# COTTAGES AT GENERATION VILLAGE

## WILLARD, GREENE COUNTY, MISSOURI

PM: RS  
PC: RS  
PLAN SET NO. \_\_\_\_\_  
MASTER COVER SHEET  
ADDENDUM #2

ISSUE/REVISIONS  
12 AUG 2022 ISSUE SET  
03 NOV 2022 ADDENDUM #1  
22 SEP 2023 ADDENDUM #2

4-BR UD HOUSE FINISH PLAN

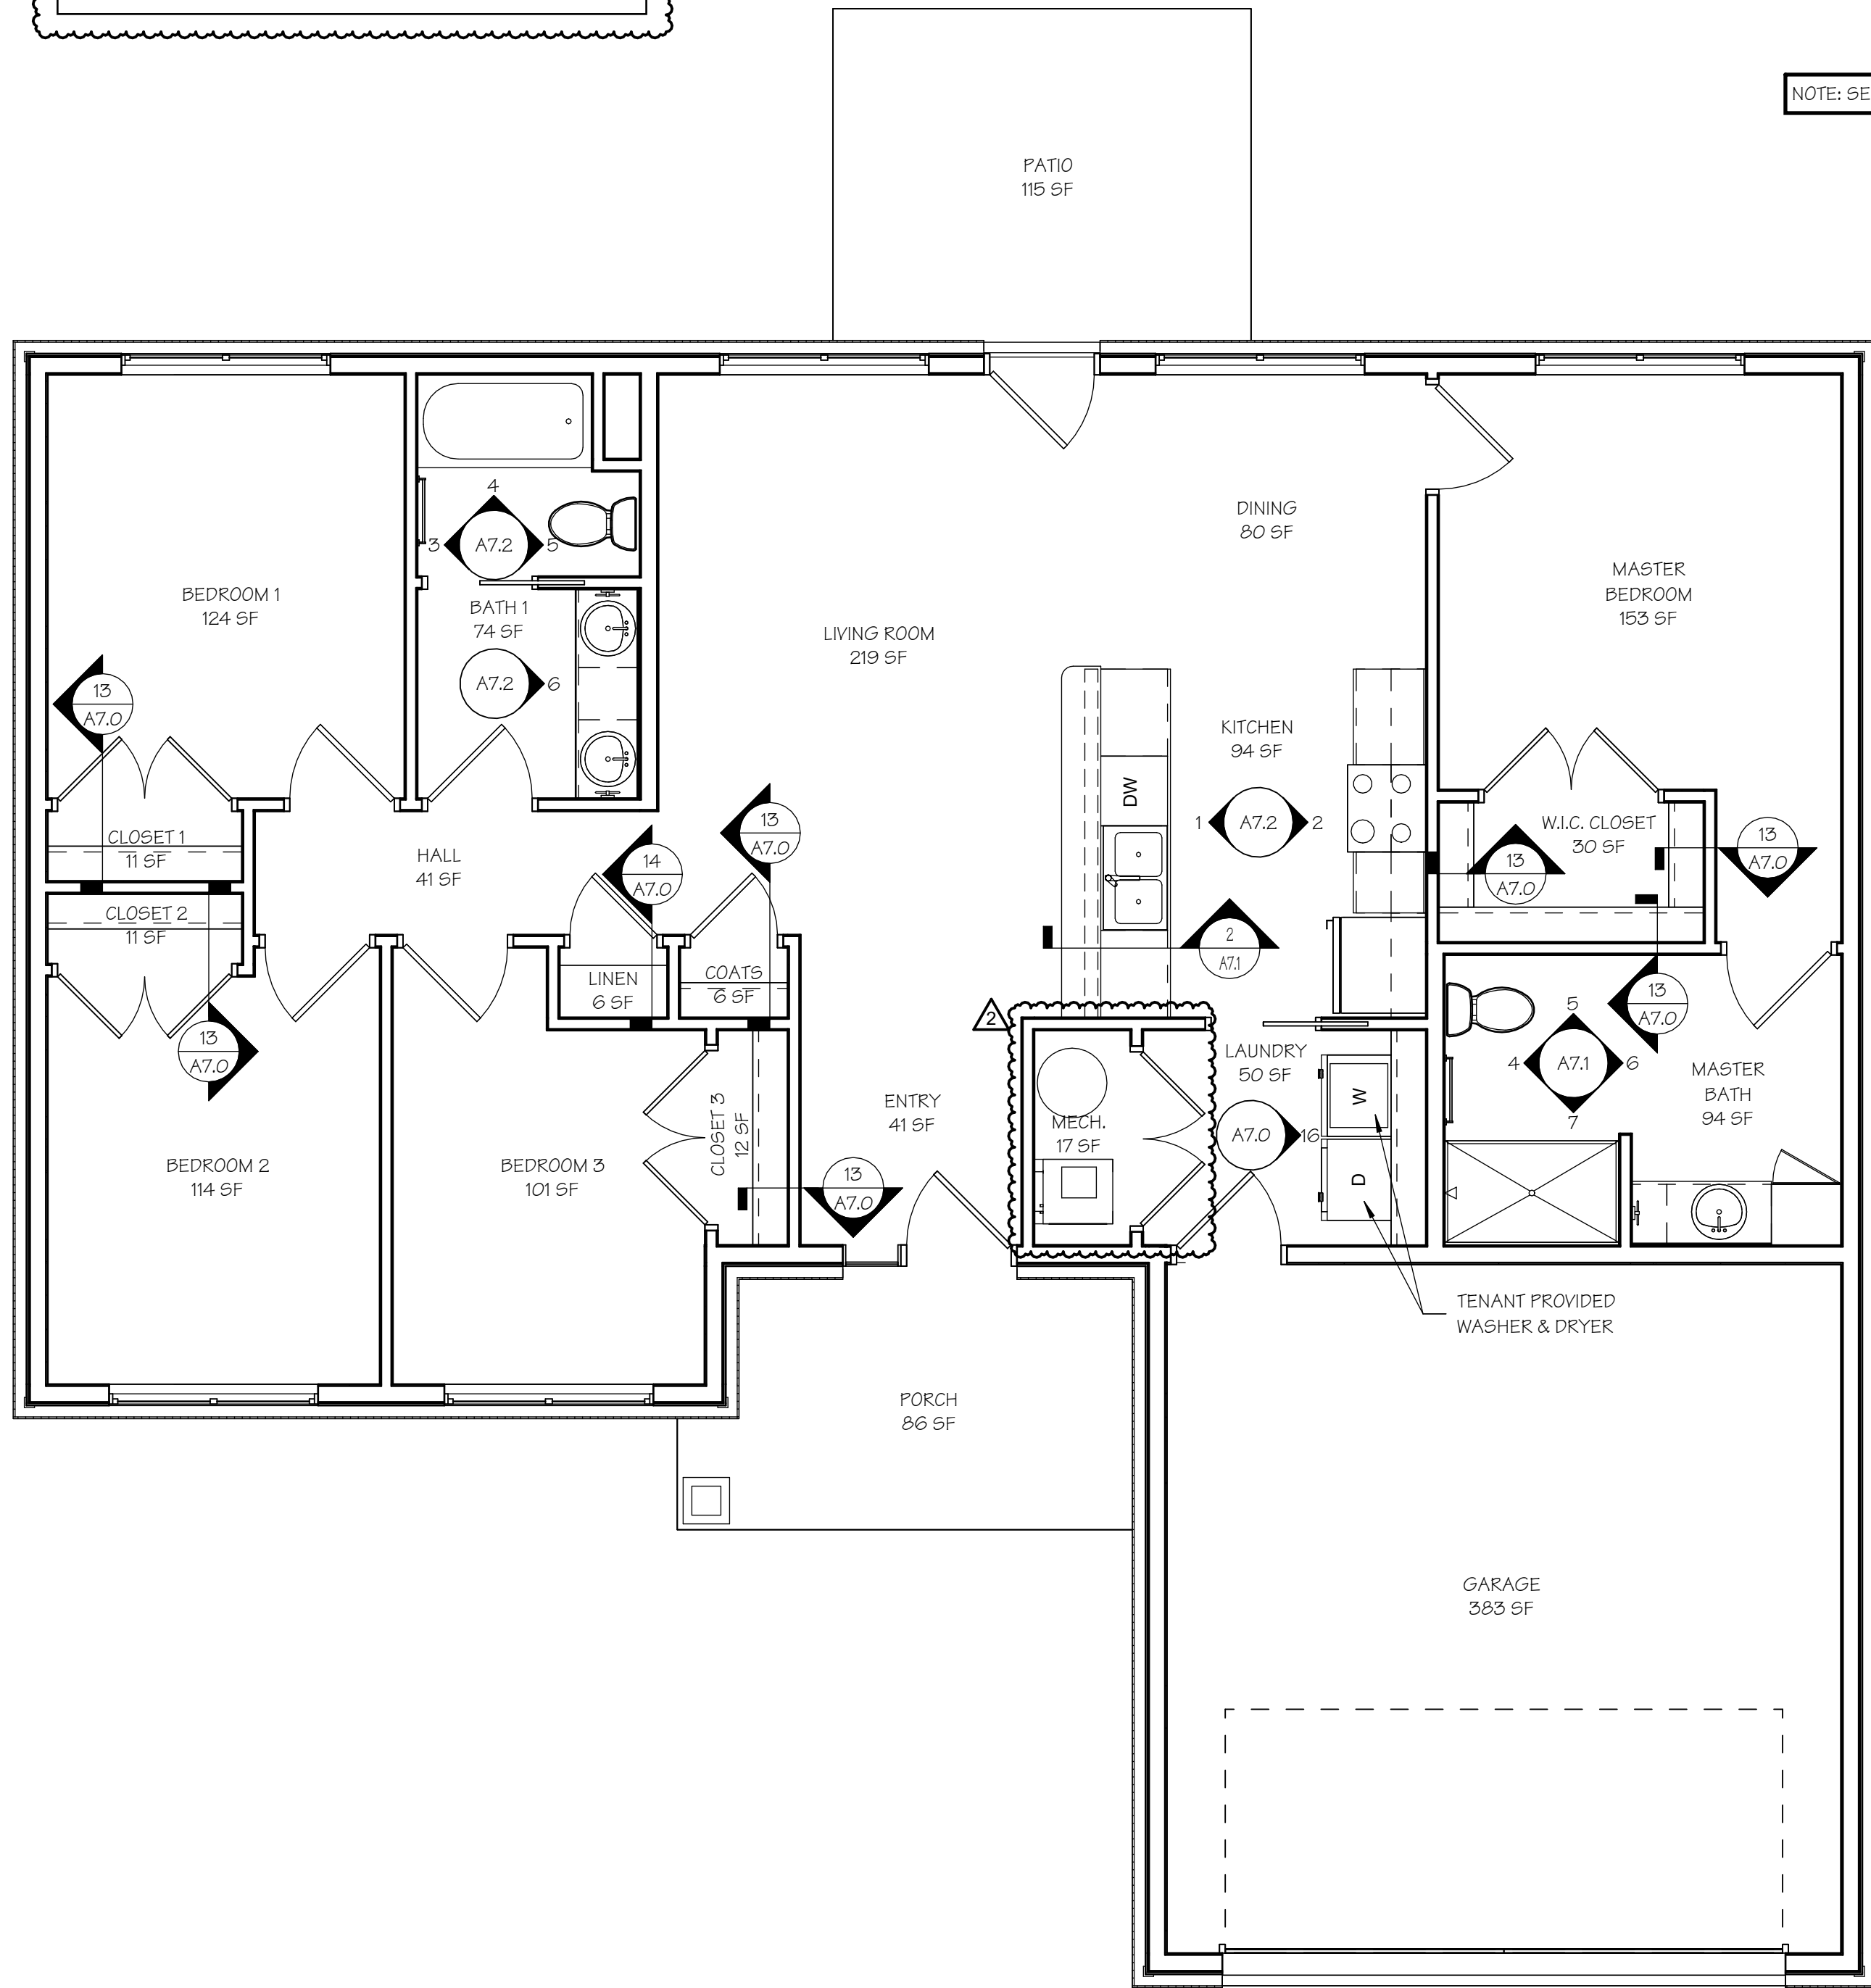
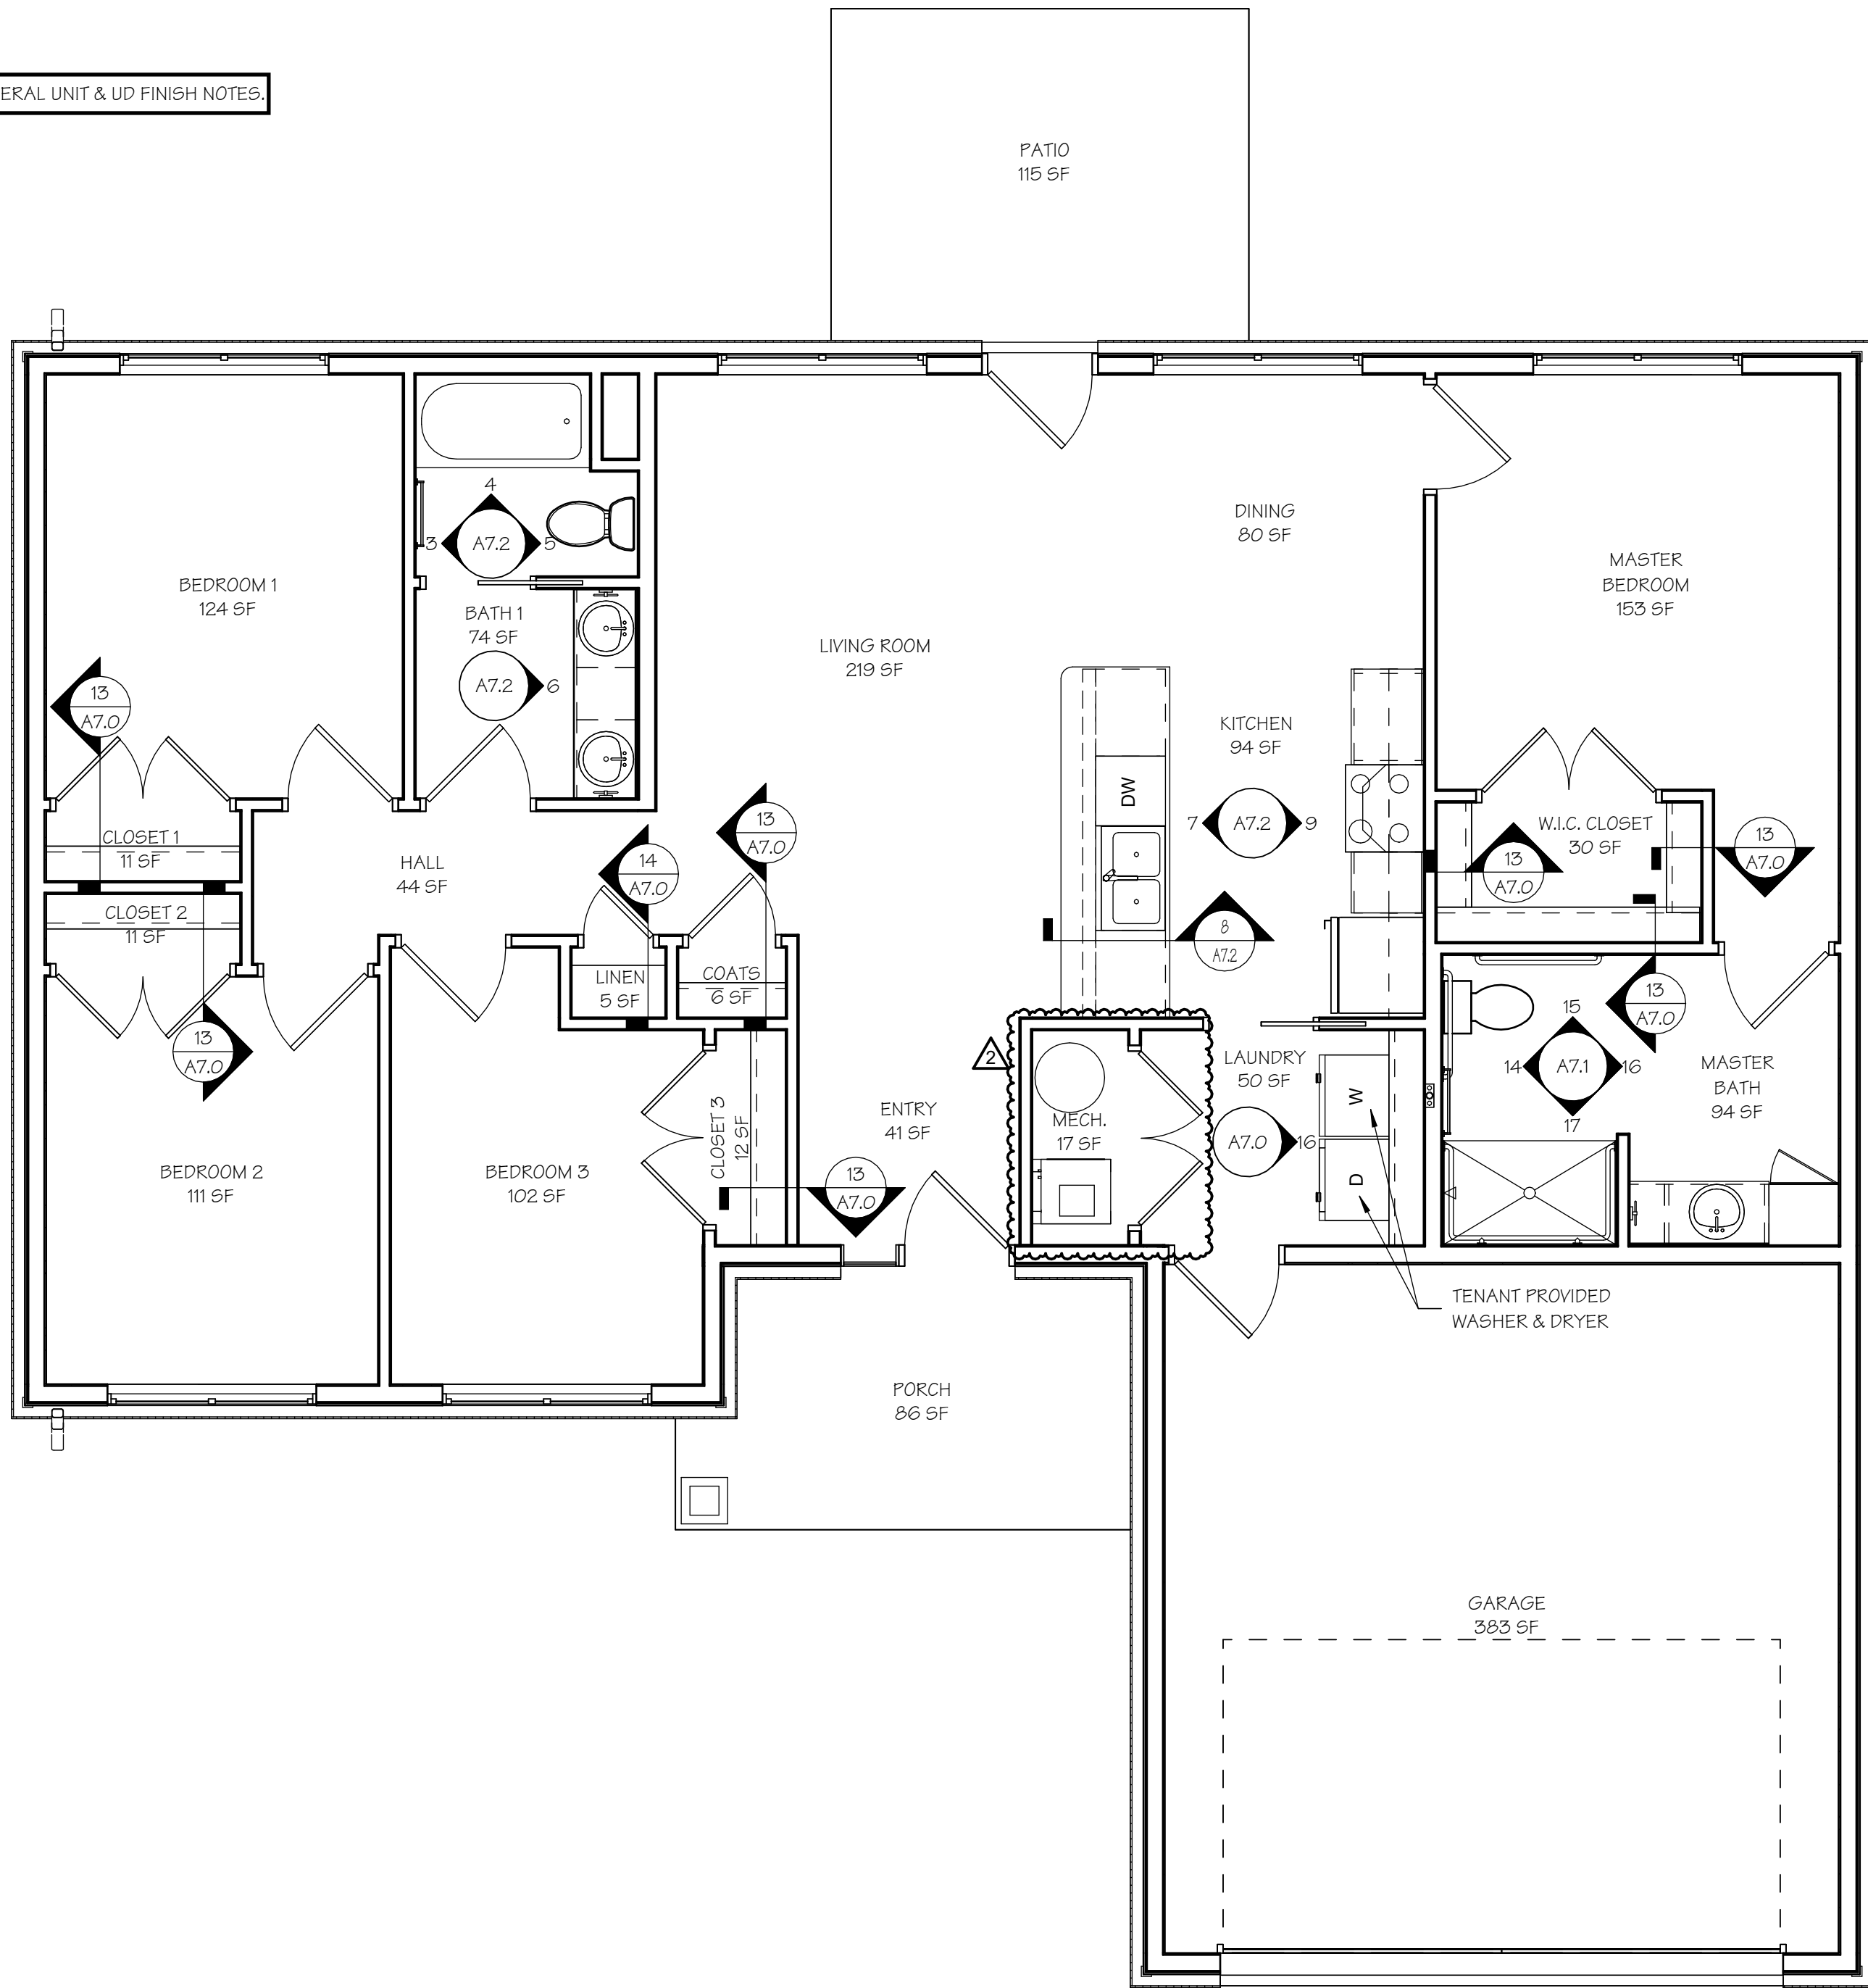
NOTE: PANTRY CLOSET HAS BEEN REMOVED FROM BOTH HOUSES.
